Docket Item #8 & 9
TEXT AMENDMENT # 2005- 0007 (8)
TEXT AMENDMENT # 2005- 0008 (9)
Potomac Yard

Planning Commission Meeting
February 7, 2006

ISSUE: Consideration of a request for (1) an amendment to the City of Alexandria Zoning Ordinance to revise the CDD Zone regulations, Section 5-600, to eliminate the requirement for a pedestrian connection for the Monroe Avenue Bridge (TA2005-0007); (2) an amendment to the City of Alexandria Zoning Ordinance to revise the CDD Zone regulations, Section 5-600, to allow for a revised Monroe Avenue connection for the Monroe Avenue Bridge (TA2005-0008).

Monroe Avenue Bridge

A. **OPTION # 1 - Sidewalk on the Bridge:**

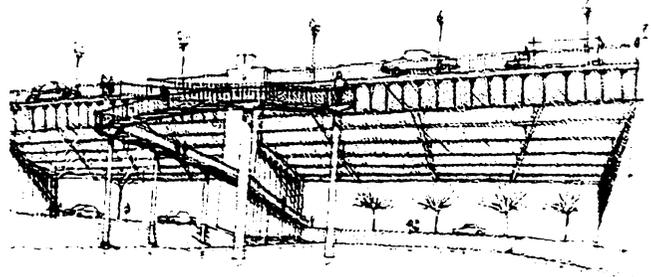
The first option evaluated by staff and presented at the community workshop is the use of the sidewalks on the existing bridge. This option does not include a direct pedestrian connection from the bridge to Monroe Avenue. While this option provides a longer route for pedestrians than a direct pedestrian connection to Monroe Avenue, the pedestrian is highly visible walking along Route 1. In addition, this option would allow the pedestrian to walk on the wider 11 ft. sidewalk, rather than the more narrow 5 ft. wide sidewalk on the western portion of the bridge. The experience of walking along the straightened bridge as a pedestrian will be greatly improved over the experience today. The straightened bridge has been designed to incorporate attractive, pedestrian friendly features.

- Other options could always be added later
- Better than alternates 2-4
- Will bicycles be accommodated?
- Police prefer this option
- After discussion, the other options are not worth saving 2 minutes

C. **OPTION #3 - Ramp on Monroe Avenue Side of Bridge:**

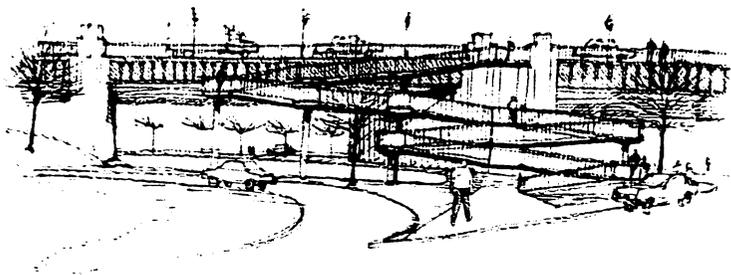
Option 3 includes a ramp connection from the west side of Route 1 that switches back and forth and lands near Monroe Avenue on the west side of the bridge. This option is ADA accessible.

The pedestrian route utilizing Option 3 also saves about two minutes of walking time over Option 1. Similar to Option 2, this ramp would appear as an appendage to the openness of the bridge design and would be even more visible from Monroe Avenue than Option 2.

D. OPTION # 4 - Stairway:

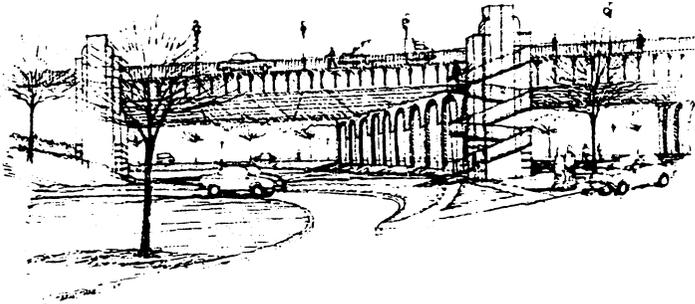
Option 4 includes a stairway connection from the west side of Route 1 and lands near Monroe Avenue. This option is not ADA accessible. The pedestrian route utilizing Option 4 saves about five minutes of walking time over Option 1.

Option 2

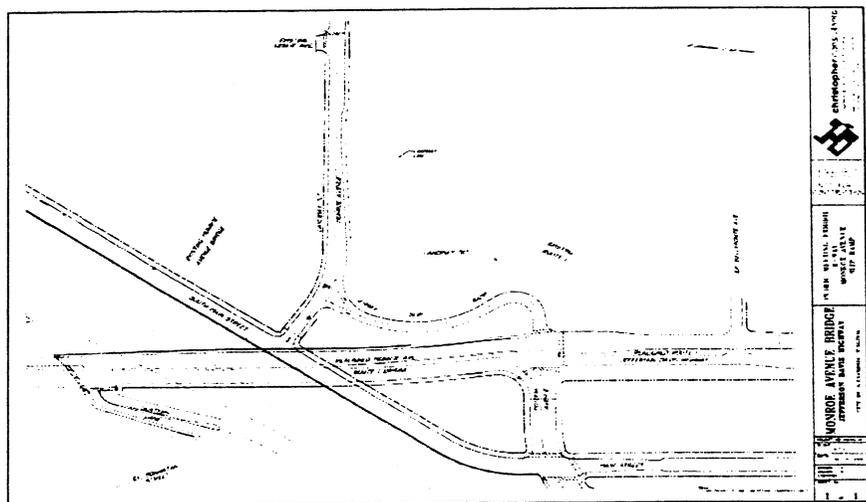
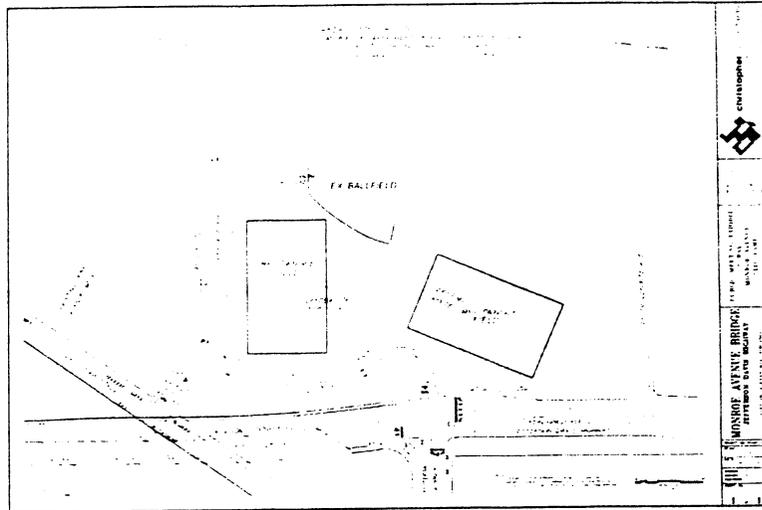
This option consists of changing the slip ramp from southbound Route 1 to Monroe Avenue, that is currently designed as one-way in the approved plan, to accommodate two-way traffic. This option makes the access from Monroe Avenue to Route 1 more direct, but eliminates one half acre of open space from the expanded Simpson Field and future school site.

This option would impact the ability to place two full size multi-use recreational fields in the expanded Simpson Field without moving a field very close to the existing homes on Duncan Avenue.

It also eliminates half an acre that could be otherwise programmed as park land. This option also severely limits the ability to construct a school on this site.

Some of the comments expressed by the community at the recent community meetings indicated that this option may minimize the concern about cut-through traffic. But many attendees also expressed concern about the loss of area in the park and school site.

- More direct access to Monroe, more through traffic
- Bad for pedestrians
- Only adds very little time to get to Route 1 S. by car vs. option 1
- Very inefficient use of land
- No improvement over Option 1
- Potential for more accidents (poor geometrics)
- Tight/windy roads
- Curvy and possibly dangerous
- Do not use: cuts into park space & makes it less useable
- Lose space - Head on accident waiting to happen

- May impair emergency vehicle access
- Two-way slip ramp has dangerous turn, emergency vehicle access may be impaired by 2-way slip ramp
- Ramp to Route 1 very narrow
- School option eliminated

Option 3

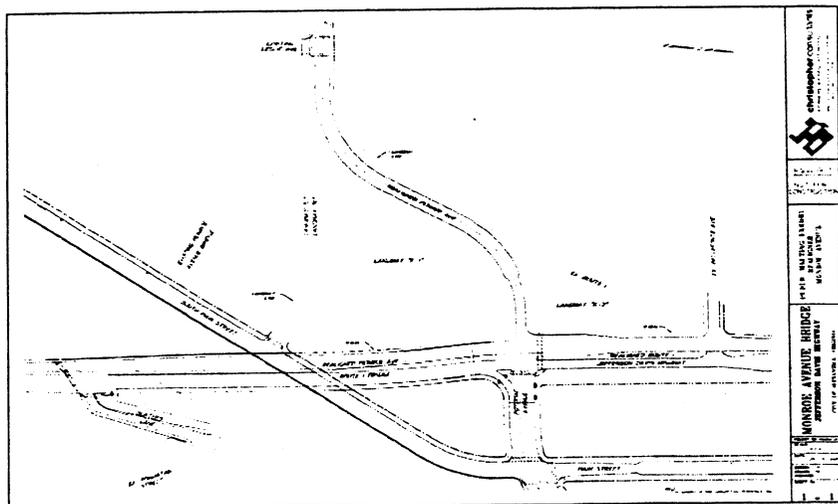
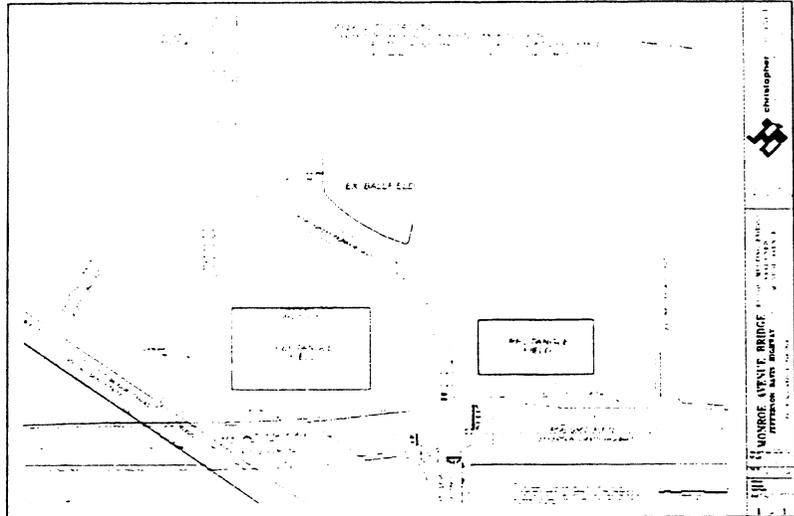
This option consists of realigning Monroe Avenue to run through the expanded Simpson Field area, along the existing right of way for Route 1. This option provides the most direct access from Monroe Avenue to Route 1, but bisects the park and future school site. There is no net loss of open space with this option, Monroe Avenue is shifted and no longer connects

directly to South Main Street. The area occupied by South Main Street in the approved alignment would become open space.

With this option, two full size multi-purpose recreational fields will not fit in the expanded park area. One field would have to be converted to a smaller size, youth-only field. The two fields would also be bisected by Monroe Avenue, requiring park users to cross the street to access the other elements of the park. This option also limits the ability to construct a school on this site.

Some of the comments expressed by the community expressed concern that this connection would encourage additional traffic from Potomac Avenue, the spine road through Potomac Yard in Alexandria and Arlington, to use Monroe Avenue to cut through the Del Ray neighborhood. Meeting attendees also expressed concern at bisecting the open space. Attendees did see this option as a way to minimize cut-through traffic on other neighborhood streets.

- Marginal- eliminates valuable options outlined in 2
- Kids crossing busy road to school
- Bad for peds
- Bisects park & school
- Concern for children crossing, sight lines on bends of Monroe Avenue
- Negatively affects usable space for park and school.
- Lose space- Road bad for future school - Cuts Simpson Park in half.
- School option eliminated
- Pedestrian access drops into no where (need new path to Monroe Avenue)
- Funnels traffic from development and Crystal City into Del Ray
- Decrease in school space
- Can't reach Potomac Yard development without going thru Route 1 intersection

Option 4

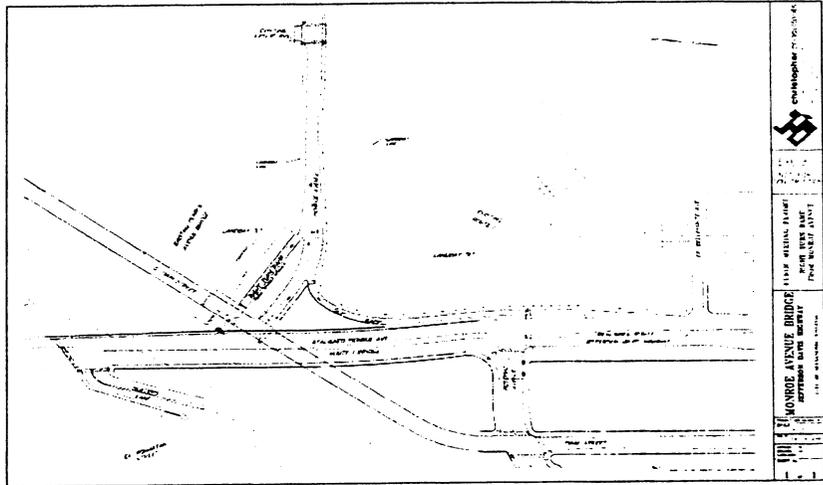
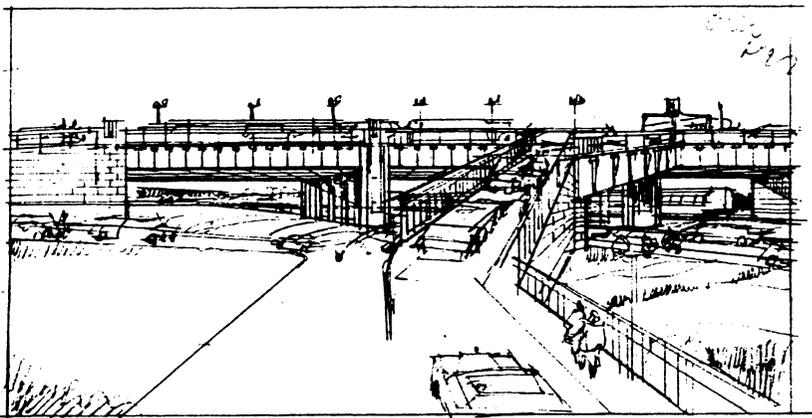
Option 4 consists of constructing an elevated ramp from Monroe Avenue to connect to the southbound lanes of Route 1 on the new bridge. This option provides a direct connection to southbound Route 1, but does not provide access to northbound Route 1. Because traffic from this ramp would have to cross in the middle of the left-turn lane for southbound Route 1 turning onto Slaters Lane, this access cannot be safely provided. This option also has significant visual and aesthetic impacts to the bridge and the future Main Street within Potomac Yard.

This option does not impact the expanded Simpson Field and future school site, but it does create a large embankment and structure connecting to the bridge at the end of Monroe Avenue. This ramp would negatively impact the openness of the straightened bridge, which were developed to provide this bridge with a sense of openness and character because the bridge will be a visually prominent element

within Potomac Yard and Monroe Avenue. This option does not provide any benefit for traffic heading from Monroe Avenue to northbound Route 1.

Most of the comments expressed by the community were in opposition to this option. The community expressed concern about the aesthetics, as well as constructing an embankment that would separate the neighborhood from the proposed development in the adjacent Landbay L.

Concerns were also expressed about the significant cost and redesign that would be necessary to accommodate this option.

This option will require the straightened bridge to be redesigned to accommodate this ramp. It will add approximately 8 to 12 months to the construction schedule, currently scheduled to last 30 months. The additional construction cost estimated for this option is about \$10 million.

- Waste of additional money and construction time
- Unsightly ramp
- Only right turn does not allow two-way traffic
- Only solves half of the problem (going to route 1 south)
- \$10 million cost to the City
- Inefficient use of land
- Out of place
- No northbound access to Route 1
- Longer construction period
- Untenable.
- Strange construction
- Awkward and expensive
- Lose space - no good pedestrian access
- No way
- Makes no sense with regard to land use and traffic
- Possible merge issue as incoming traffic from Monroe may try to cross over to Slaters
- No safe access from the ramp
- Bad for school
- Don't like this option and did not spend any time on it
- Don't like size of bridge
- No, don't support
- Could back up Route 1 so cars bail out earlier in neighborhood
